BY	DATE		<b>VENTURA COMPRESSOR STATION UPGRADE &amp; MODERNIZATION CONCEPTUAL PLOT SPACE FOR SCE SUBSTATION W/ TWO 66 kV LINE SERVICES</b>							
		DESIGNED: G.PARE	07/10/23									
		DRAWN: M.RIZO	07/10/23		<b>33900-3903-D-PIP</b>							
		CHECKED:										
		PROJ. APV:			DWG CLASS: 09_39   DWG DIST: 114 SCALE: 1"=40'-0"							
		SCE ENG. APV:										
A	07/17/23	MCR	GJP	E15043	ISSUED FOR REVIEW	91651	ENG. FILE NO: E15043	DWG CLASS: 09_39   DWG DIST: 114	DRAWING NUMBER	33900-3903-D-PIP	REV	A
REV	DATE	DRAWN	CHECKED	PRJ. APV	SCE APV	ENG. FILE NO	DESCRIPTION	SCALE

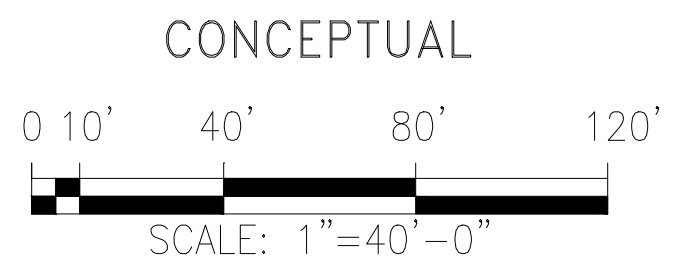
See Note 1

See Note 1

Note 1: The Plot Space shown does not account for unobstructed width of not less than 20 feet all around as required as per Ventura County Fire Department Standard 501.
